QUALITY IMPROVEMENT SHEET (Q.I.S.)

MODEL CODE YM/MODEL NAME	TITLE	QIS CONTROL #
CG6	KEY COMES OUT OF IGNITION SWITCH WHILE IN GEAR	MV20040426180508
02/ACCORD		
OCCURRENCE DESCRIPTION		
Key comes out of the Ignition Switch while the transmission is in gear

Quality Committee (JQC)

Key comes out in ranges other than P

Occurrence mechanism of the failure

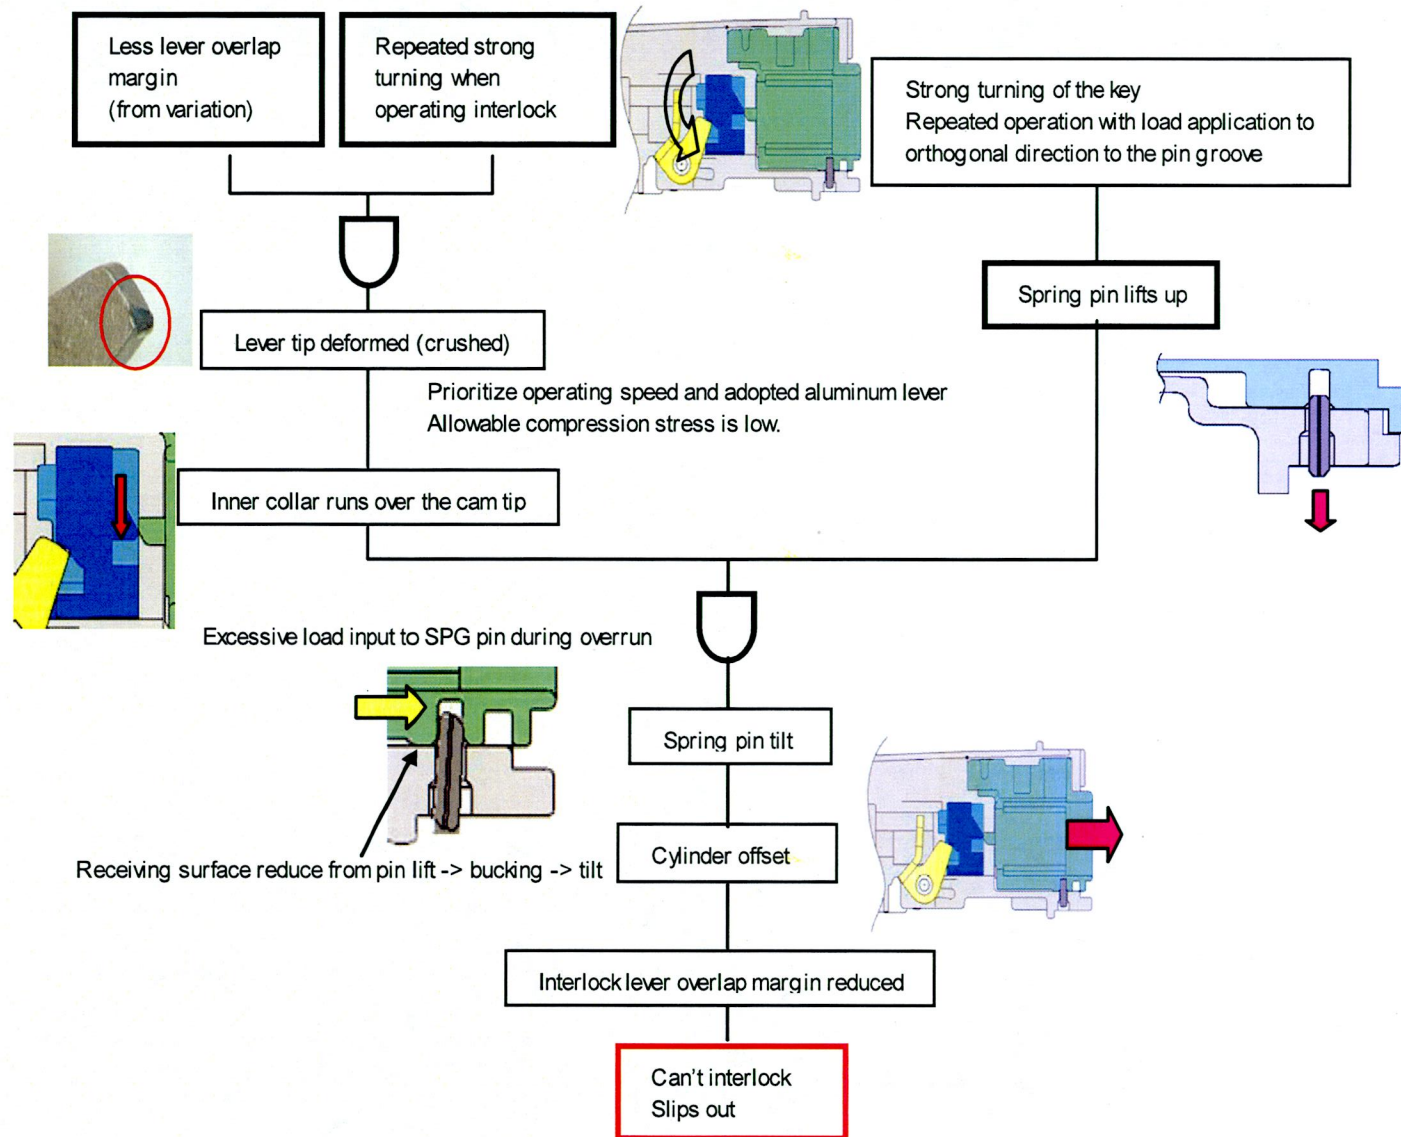
Regarding the failure this time, the overlap margin when returned was 1.04 mm compared to the required margin 1.06 mm. Repeated strong turning of key beyond expectation at interlock blocking with overlap margin of 1.06 mm or below leads to slip out. Therefore we judge that the failure occurred with the returned part due to worn lever from repeated strong turning of key beyond expectation.

Required overlap margin with consideration of SPG pin lift up. (US Market) <Separate sheet-2>

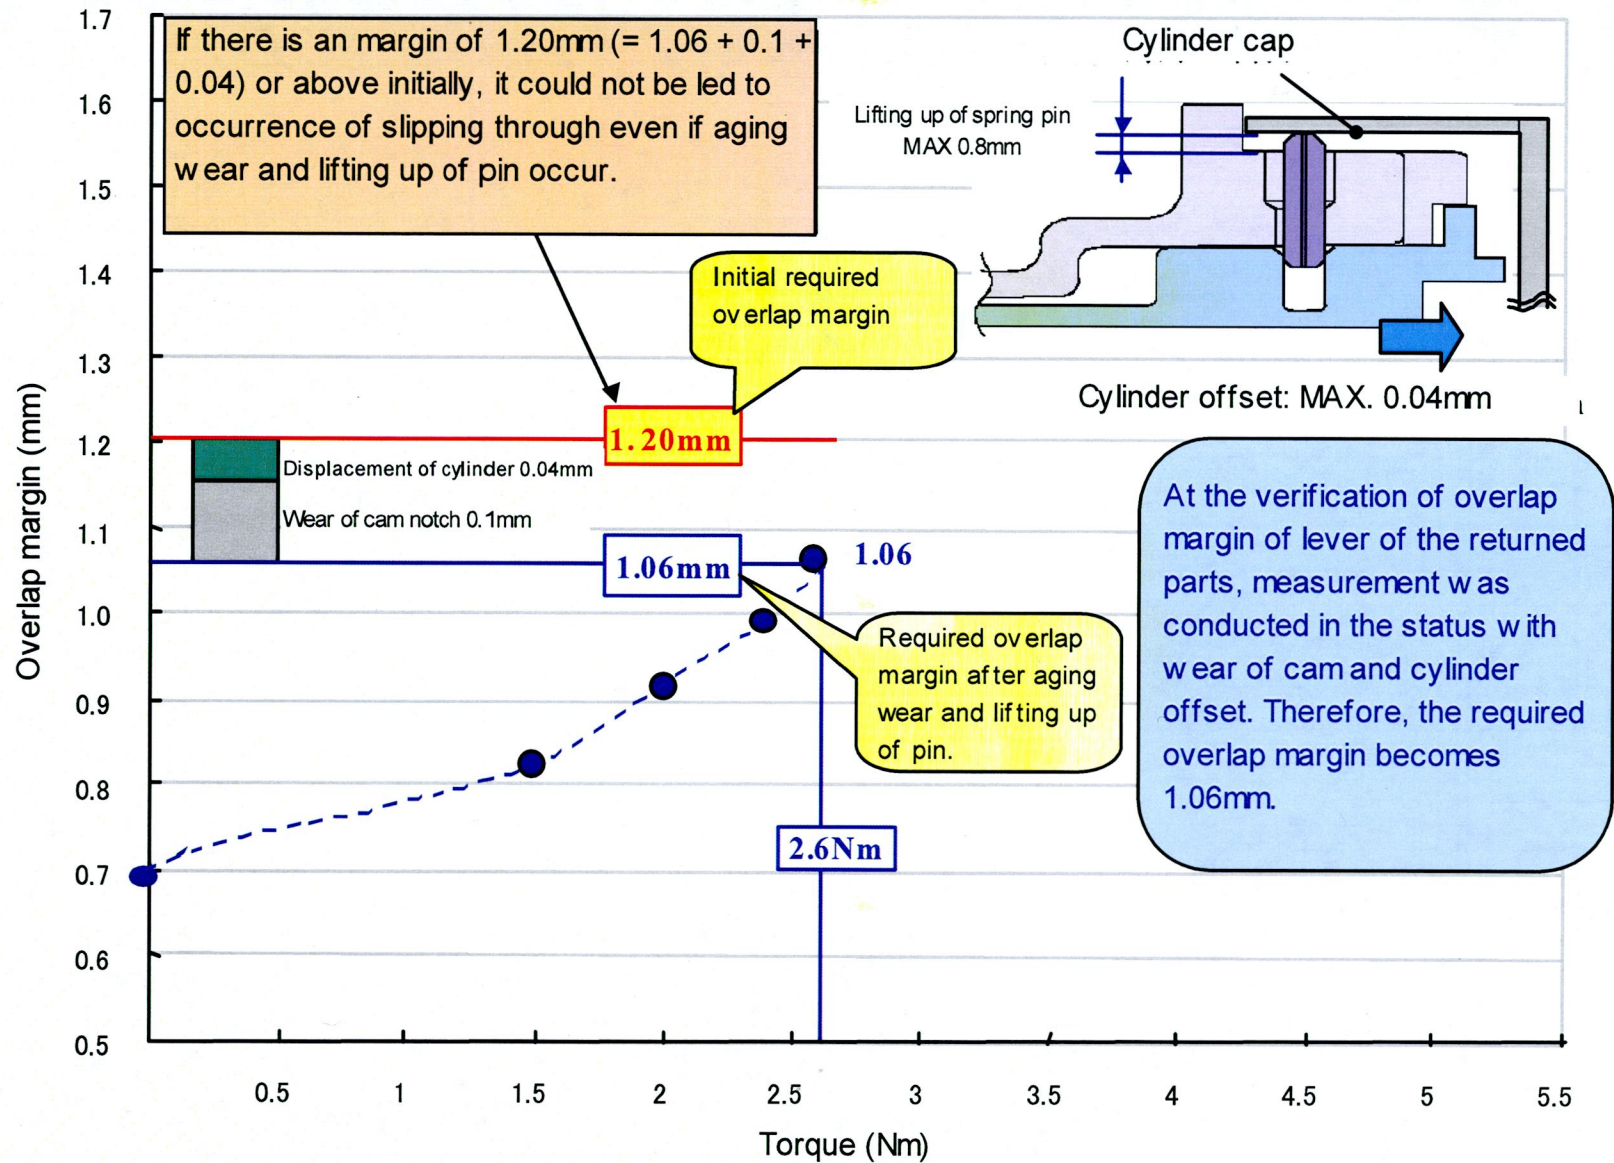
Required overlap margin for lever rigidity is 1.06 mm.

(Initially required margin becomes 1.20 mm when considered aging deterioration and spring pin lift.)

Condition of market failure part returned from US (Css build ACCORD Type I N=7)

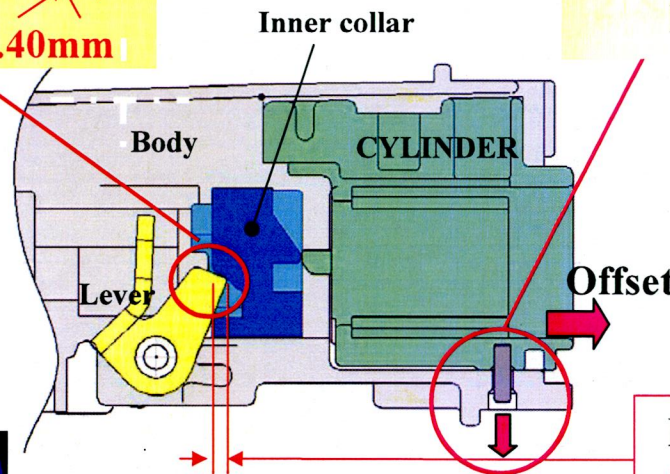
① Lever tip deformed

Tip R increase, lever can be kicked up easily

Lift (0.51 ~ 0.74mm) + tilt

Reduced lever overlap margin
Overlap margin of failed part 0.77 ~ 0.96mm

Increase lever overlap margin (replacement to special lever)

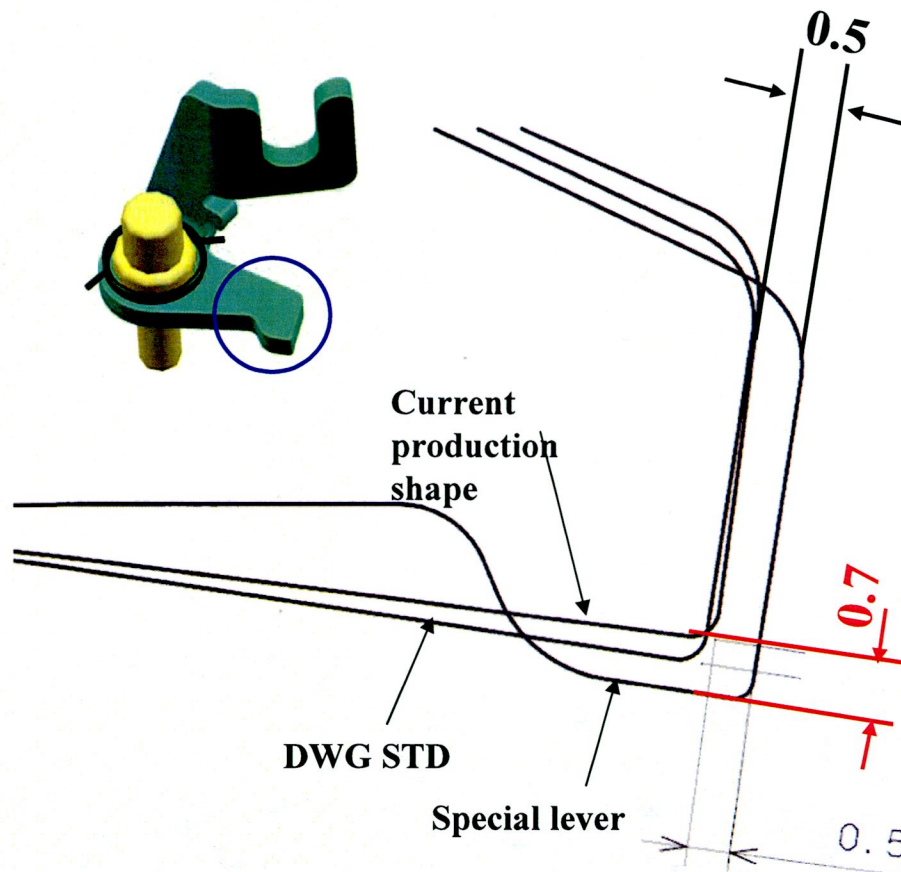
Increase overlap margin by 0.7mm more than production lever, to secure overlap margin more than the limit value.

(increase 0.5mm in longitudinal direction, so it won't result in overrun easily)

Even with Type I where the overlap margin is the smallest, this can secure overlap margin of 1.75mm, providing enough margin for the required 1.20mm.

Replace levers on all affected vehicles to special lever.

Occurrence mechanism (crushed lever tip)

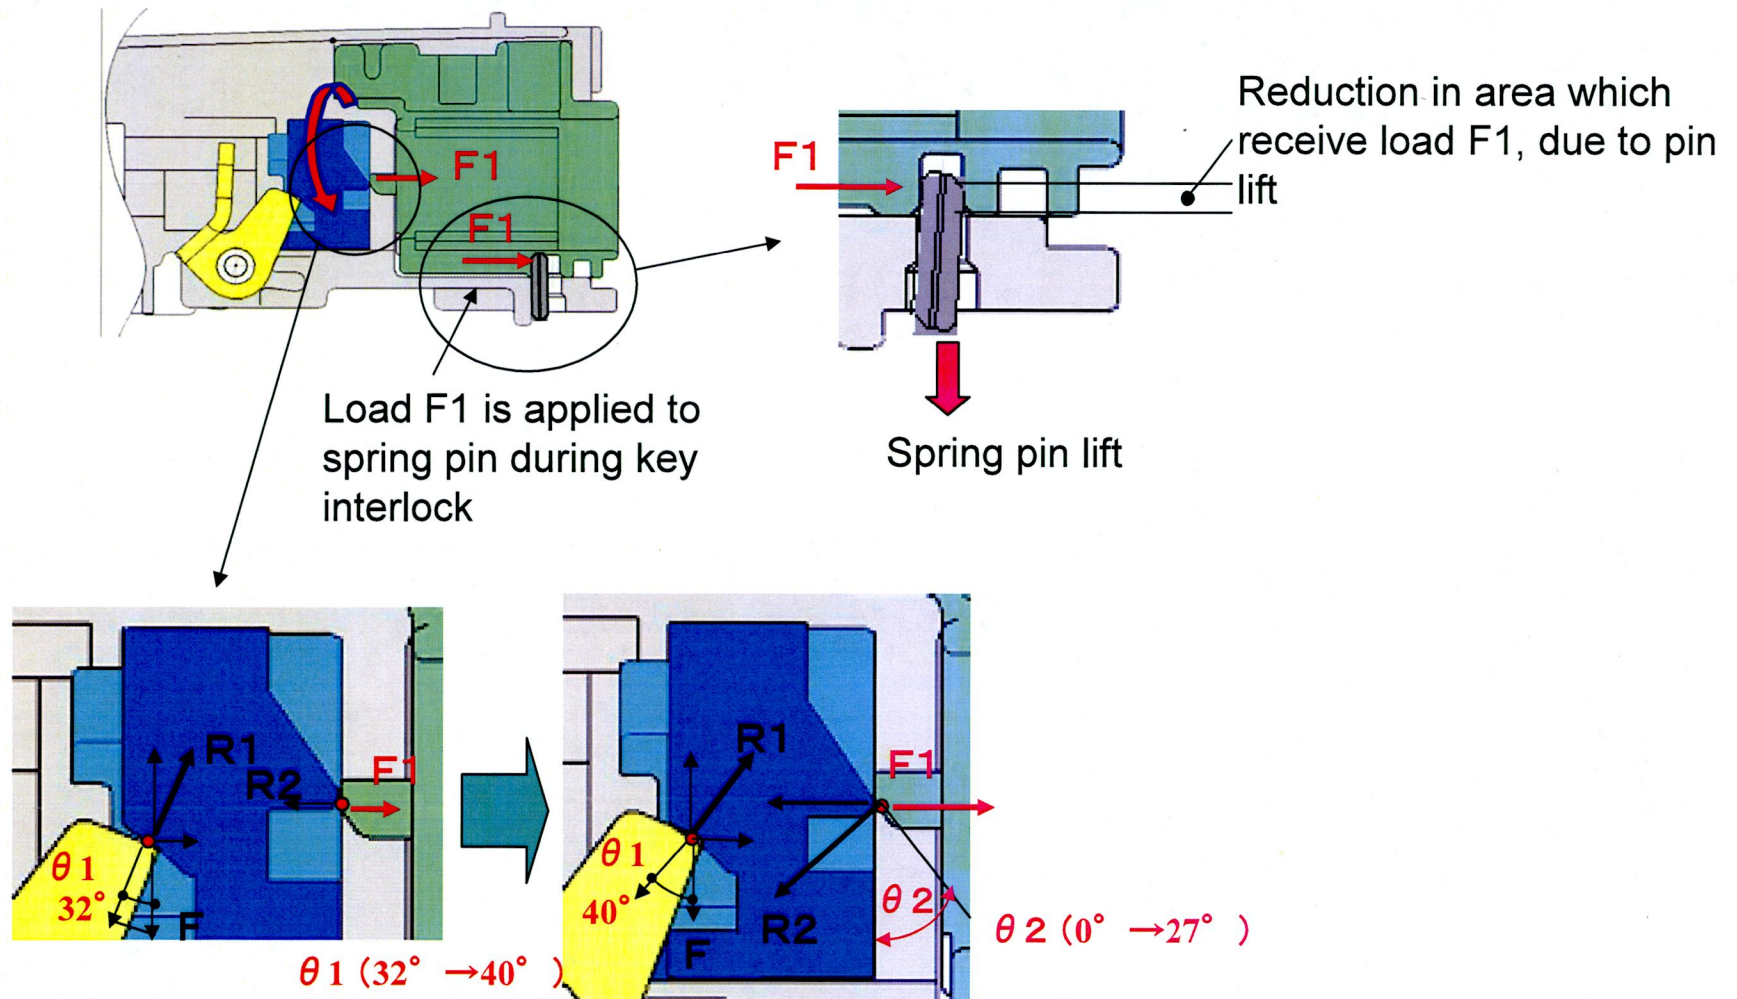
Deformation will not progress with contact surface more than 0.78mm^2

With less lever overlap margin, contact area will also be small, so more buckling deformation = slackening of the lever occur.

2. Failure part investigation results - Summary

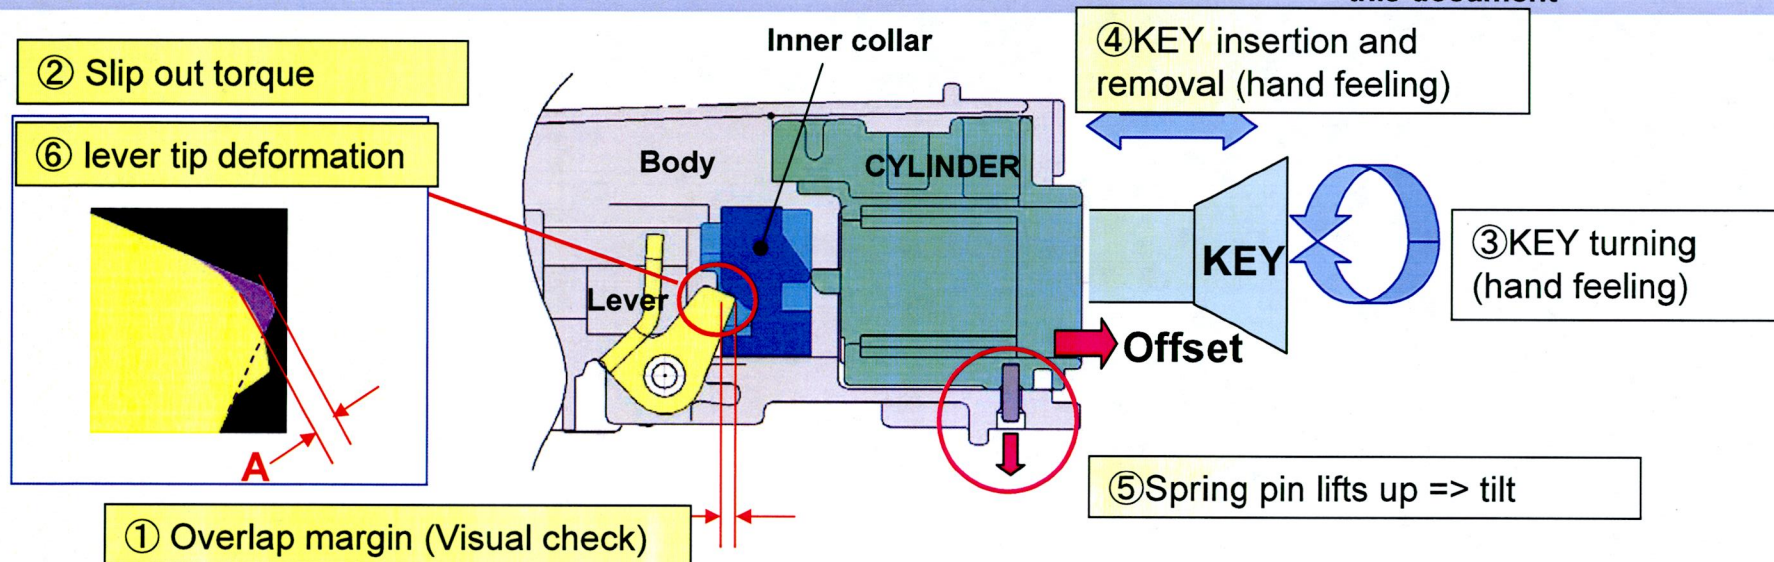
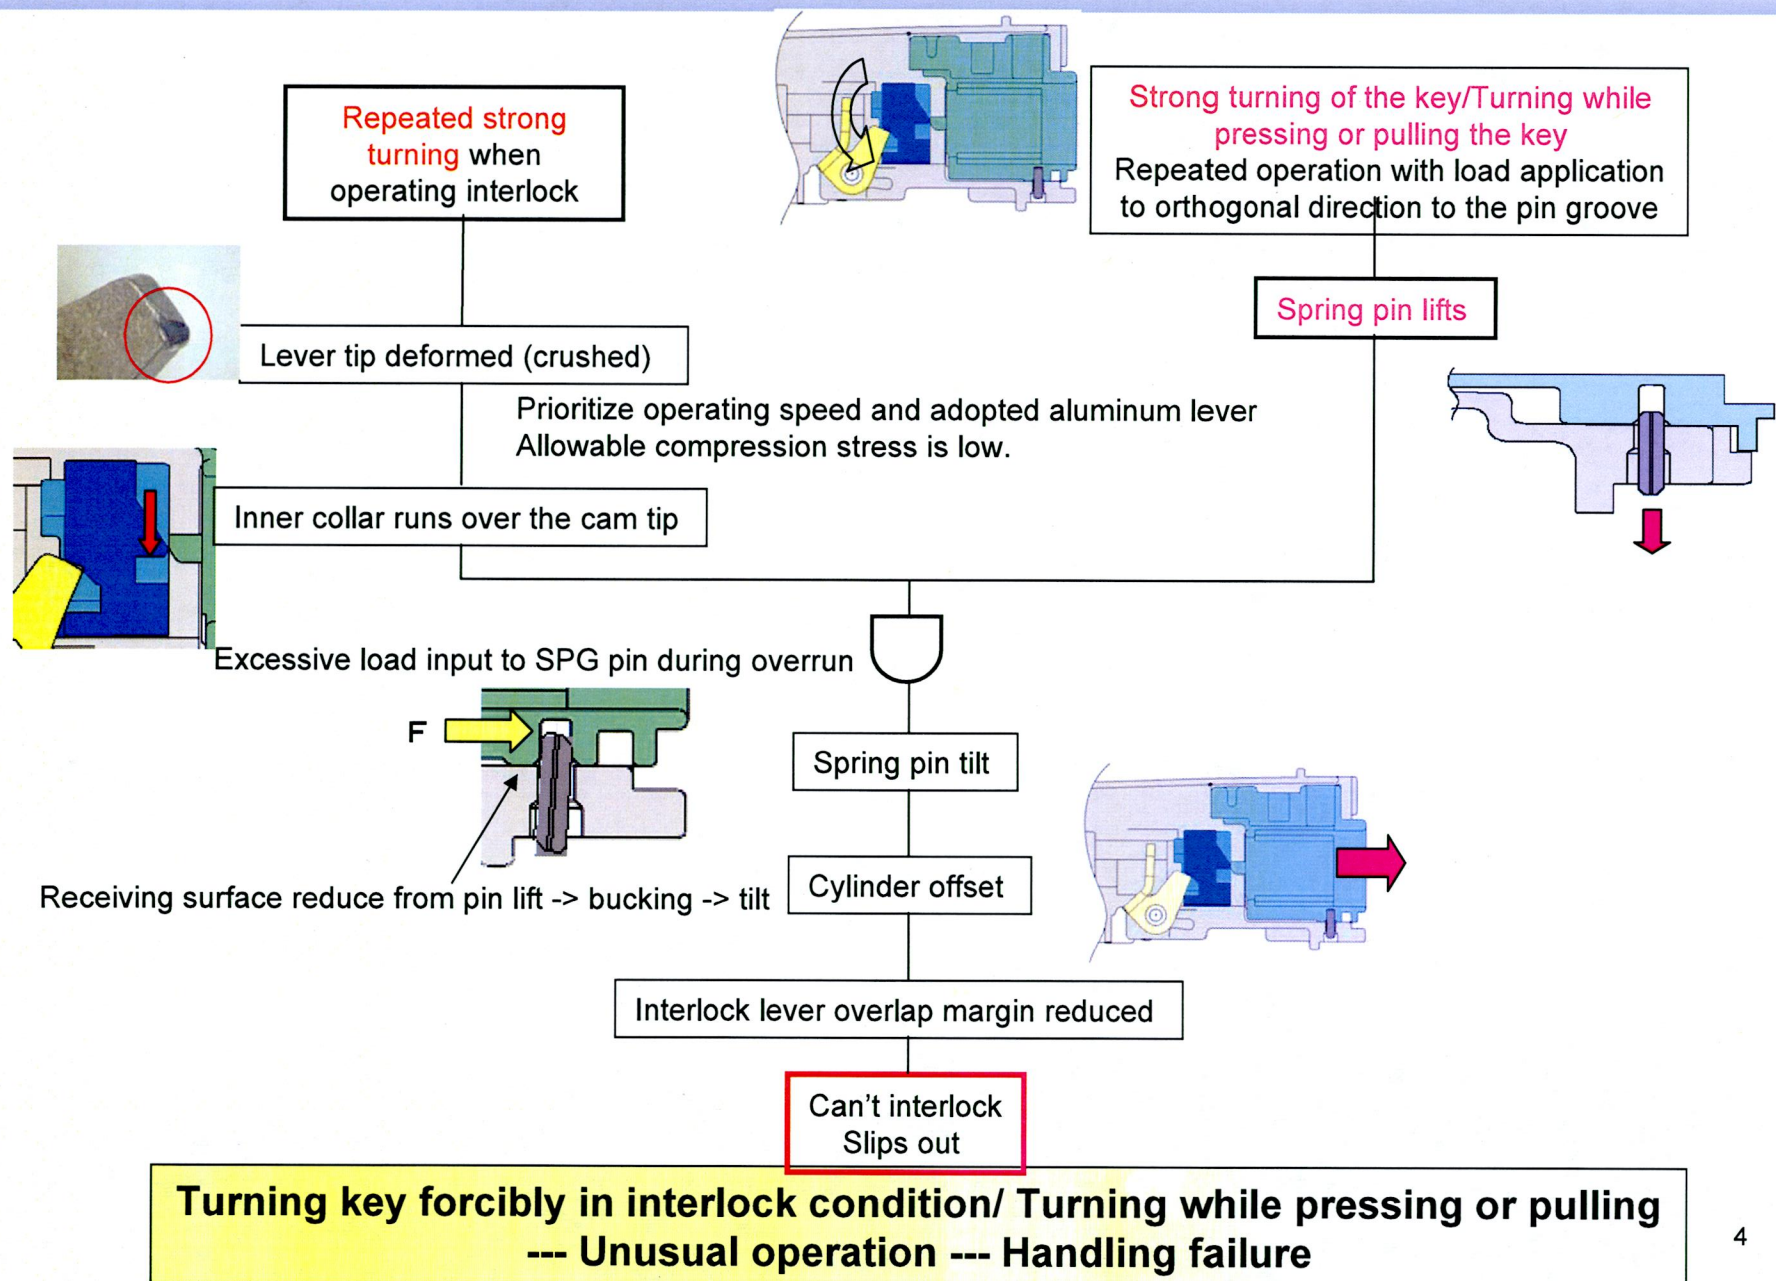
① Lever overlap is 1mm or below.

② Slip out was recreated.

⑤ SPG pin lifts up.

⑥ Trace of strong rotation is on the lever tip shape.
